March 9, 2012

FOOD STOREROOM BUILDING RENOVATIONS at ARUBA SURF CLUB

ADDENDUM NO. 3 (Post Bid VE)

FLOOR PLAN
 MECHANICAL
M2.0

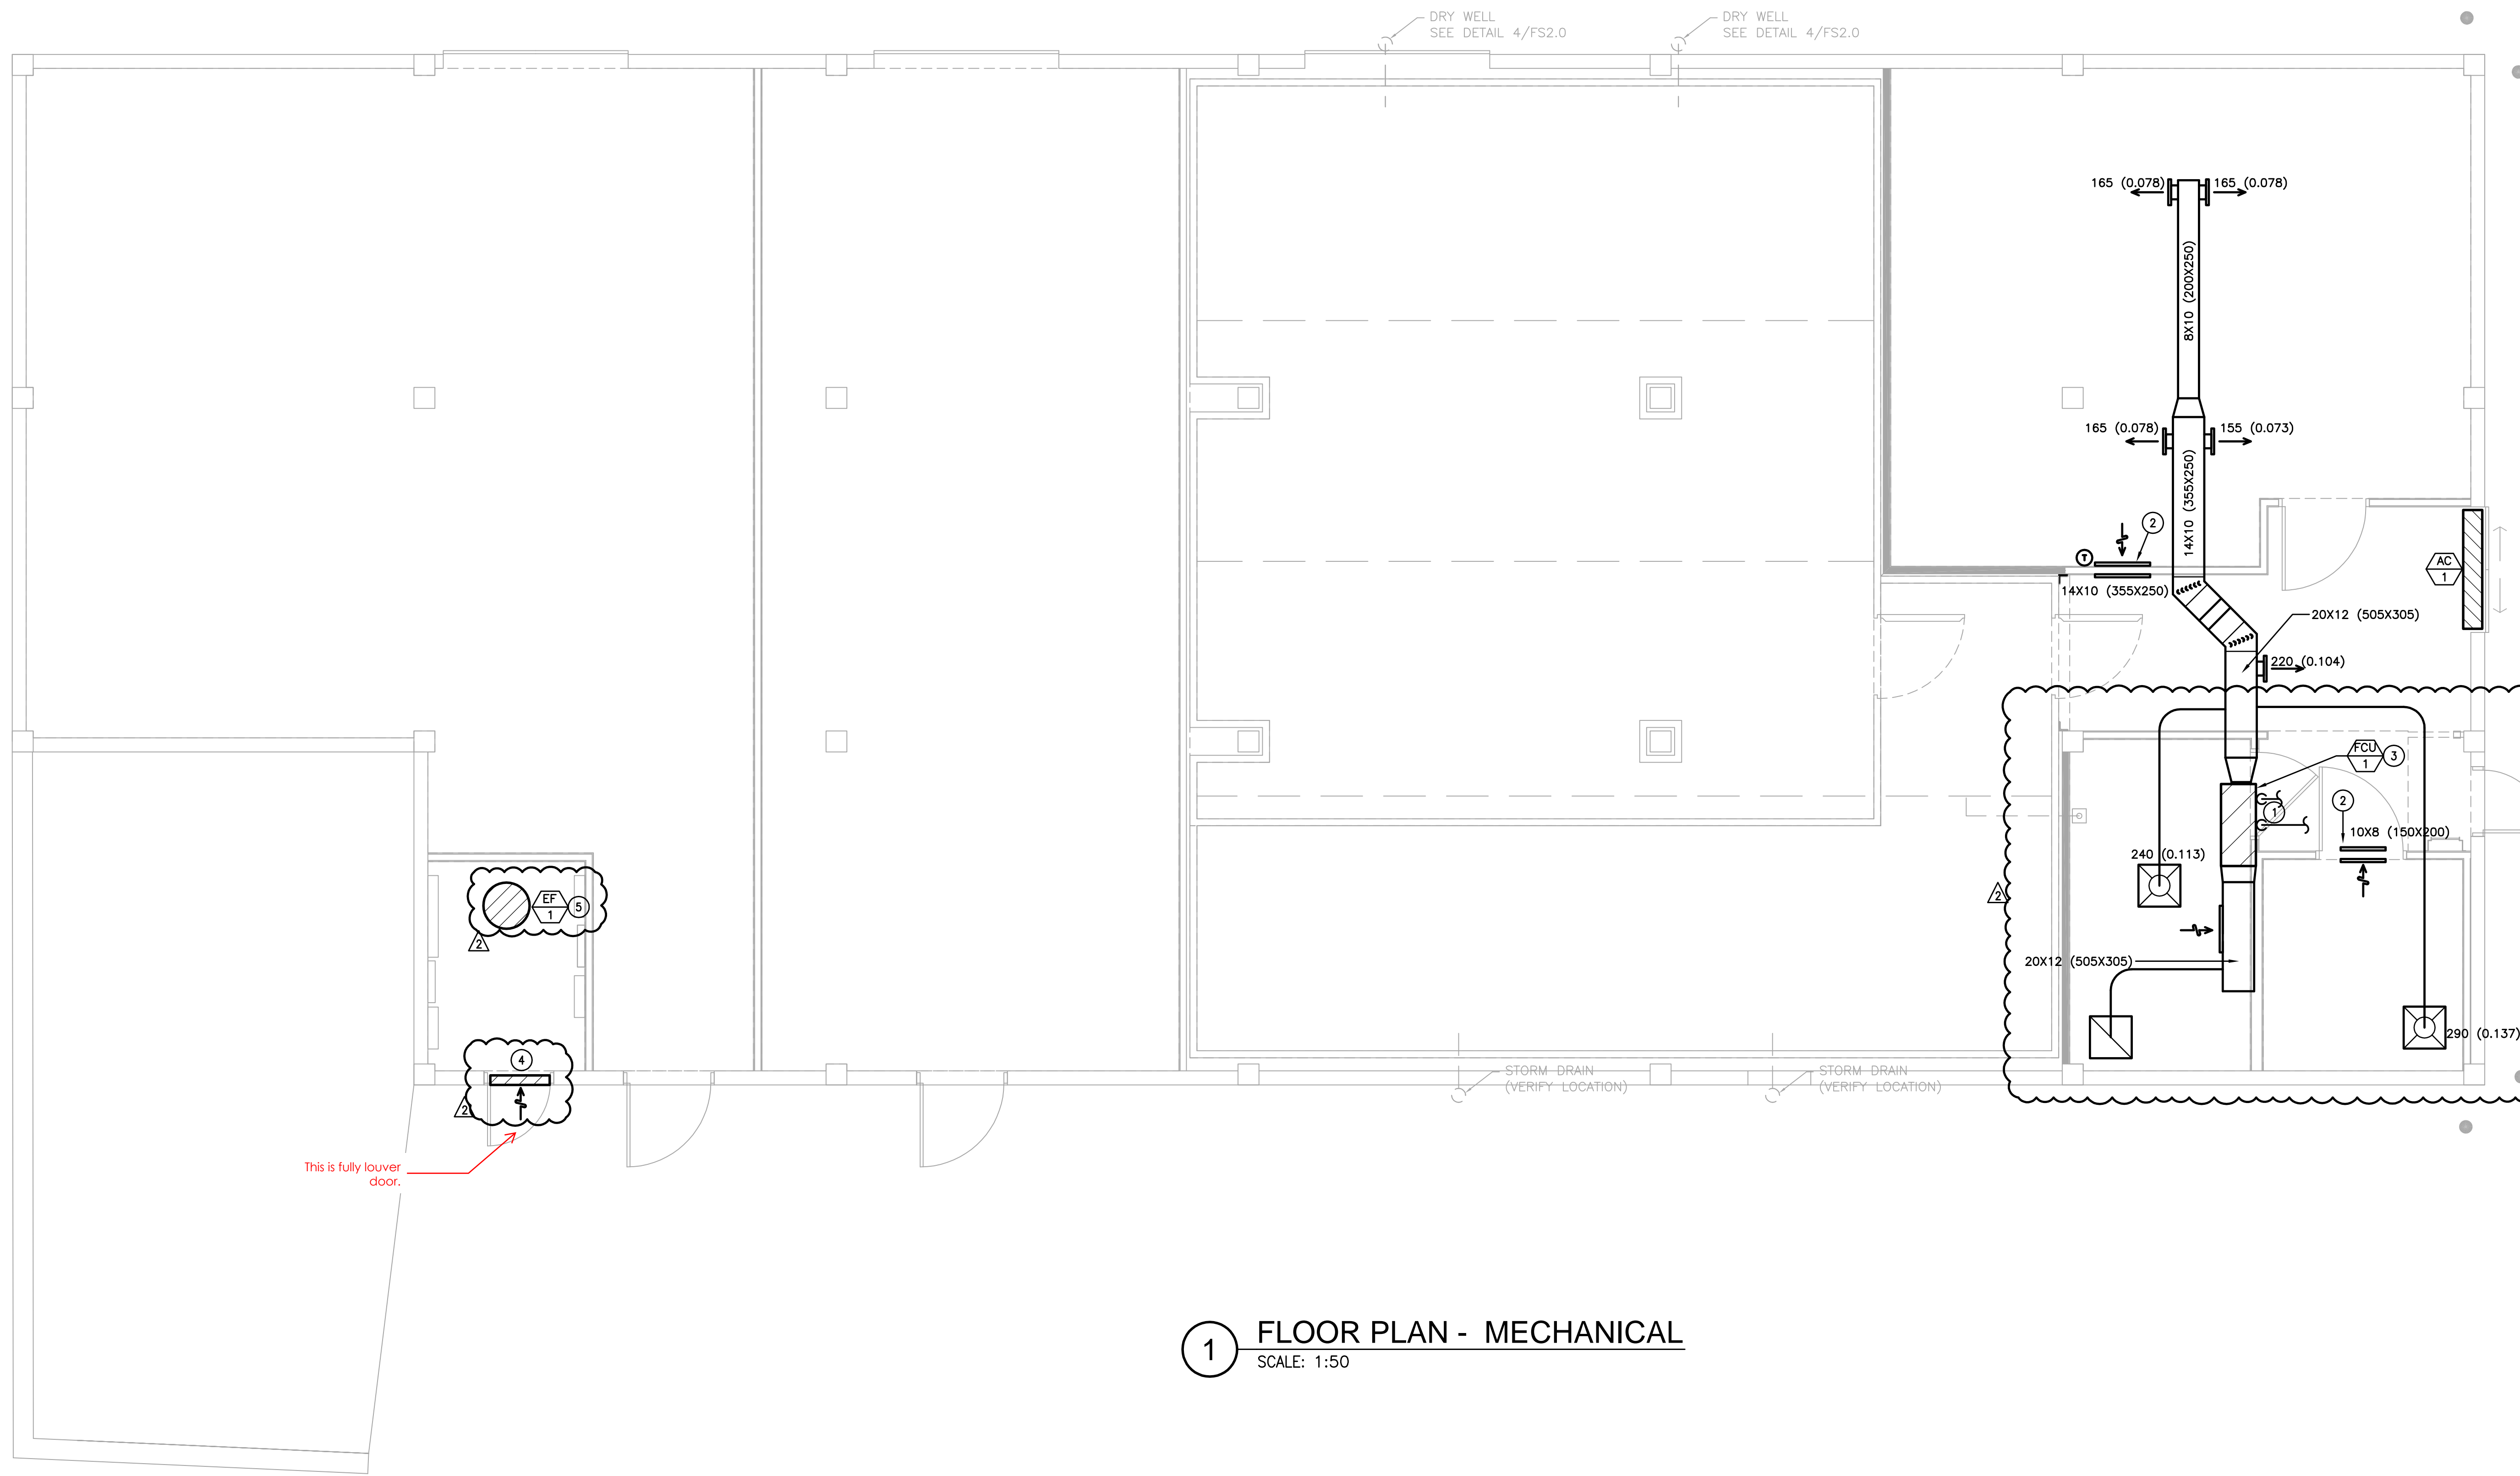
Sheet M2.0 - The following are VE modifications. See revised M2.0 sheet

- Delete FCU-1 in electrical room. Provide and install roof mounted exhaust fan. Provide louver in door.
- Change water cooled heat pump to split system FCU. Locate condenser units on the roof.
- Refrigeration equipment has been moved to the roof.

M4.0

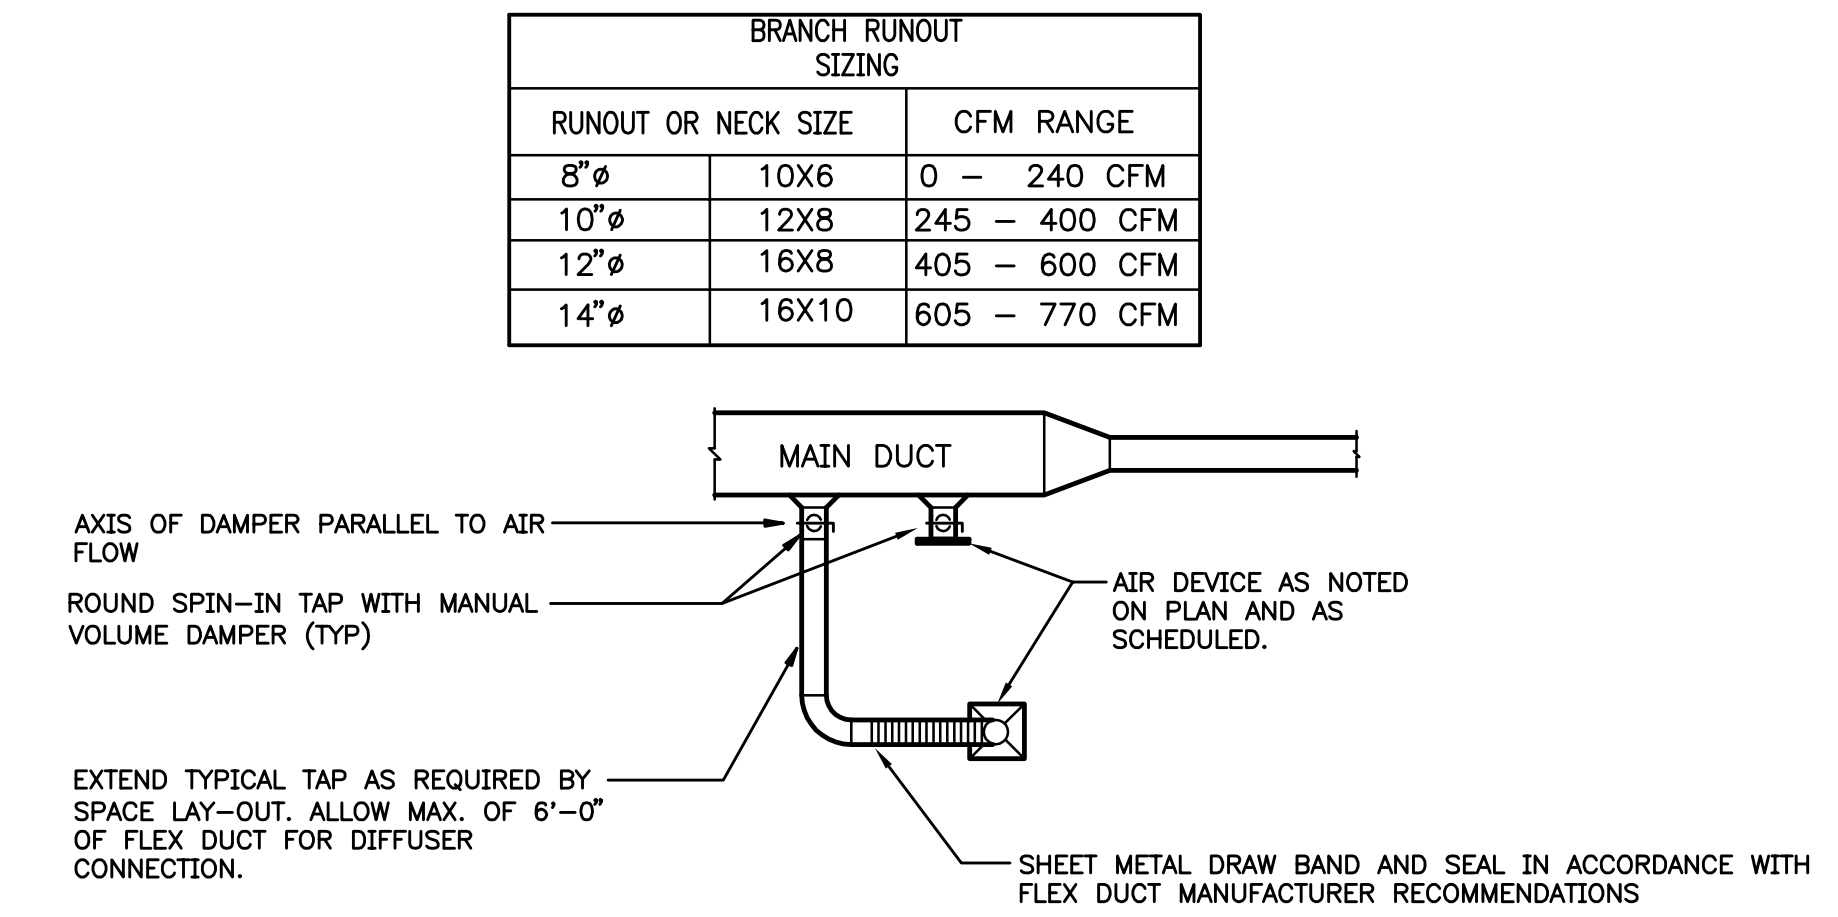
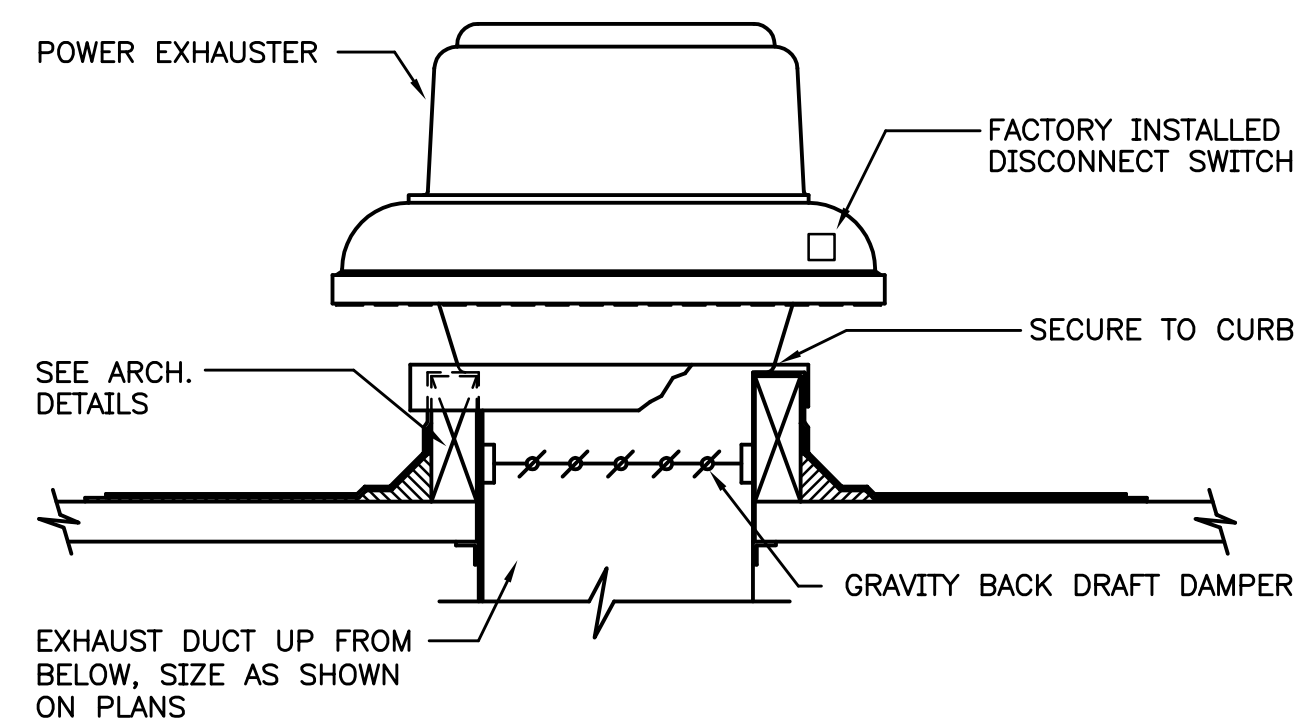
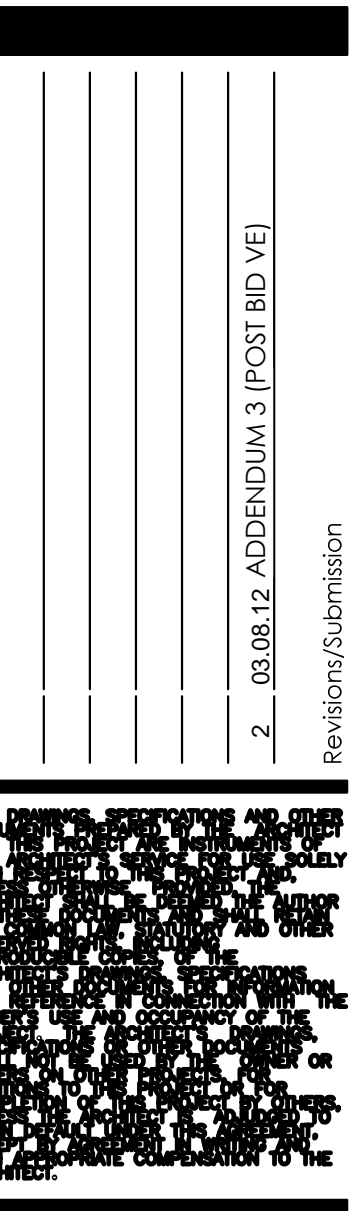
Sheets M4.0 - The following are VE modifications. See revised M4.0 sheet.

- Details 2, 4 & 5 shall be revised to change all condensing water cooled equipment & piping to air cooled equipment.

1 FLOOR PLAN - PLUMBING
SCALE: 1:50

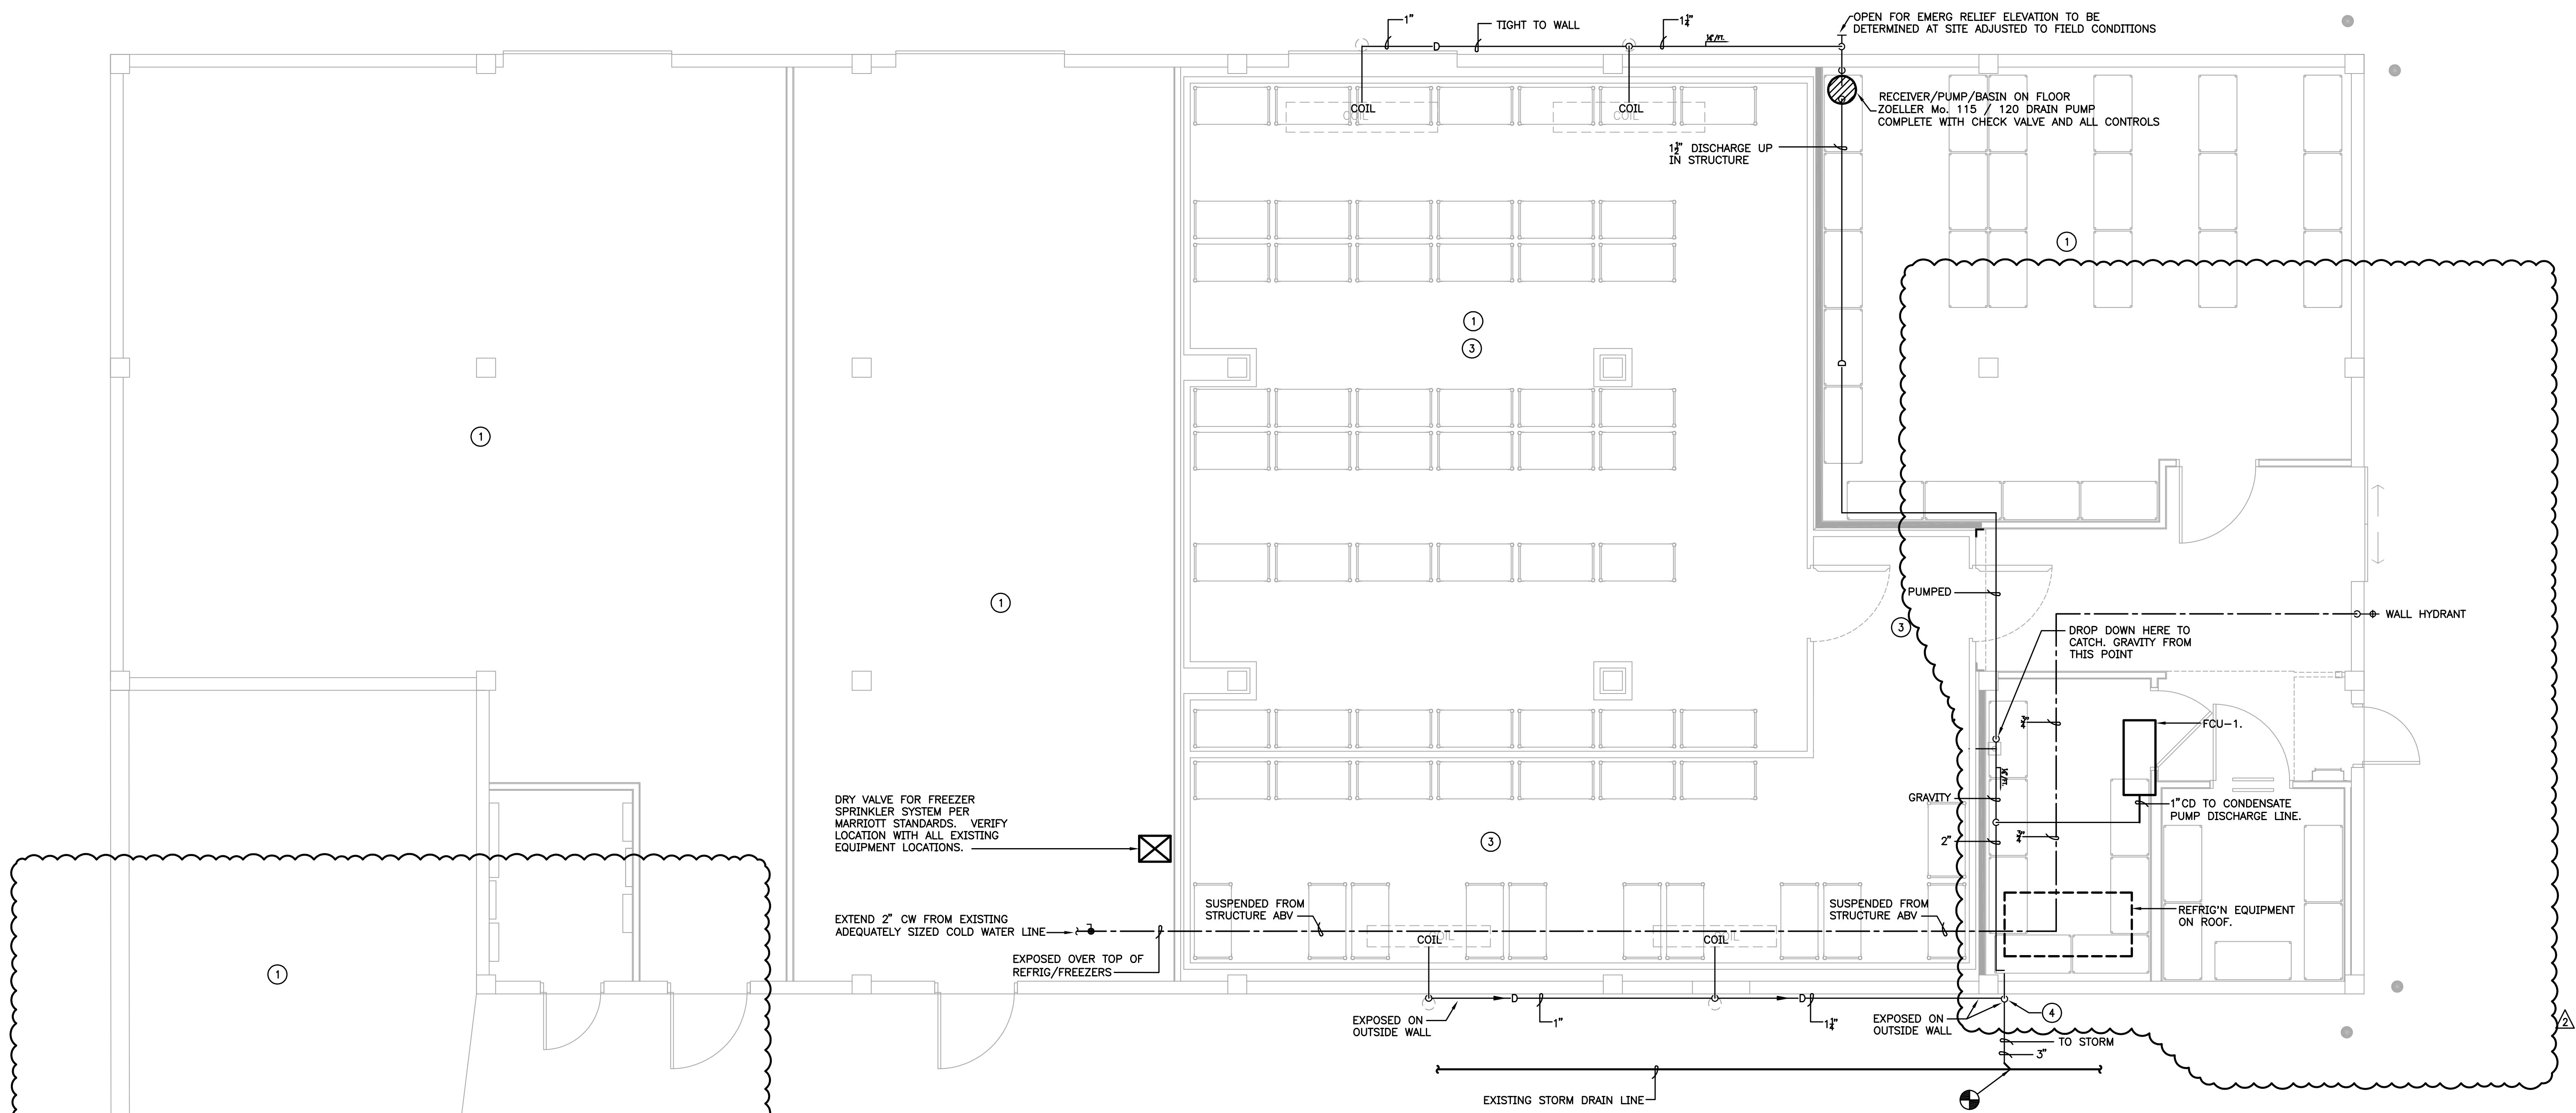
Sheet P2.0 - The following are VE modifications. See revised P2.0 sheet.

- Delete hand sink/eyewash station. Move single hose bib to the exterior of the building.
- Delete all piping on plans and details associated with condenser water for A/C and refrigeration equipment.
- Delete 3 compartment sink being bid as an Alternate.
- Delete sprinkler work associated with cover at mezzanine.
- Delete details 2, 3, 4, 5 & 6
- Delete condensate line work from Electrical Room.
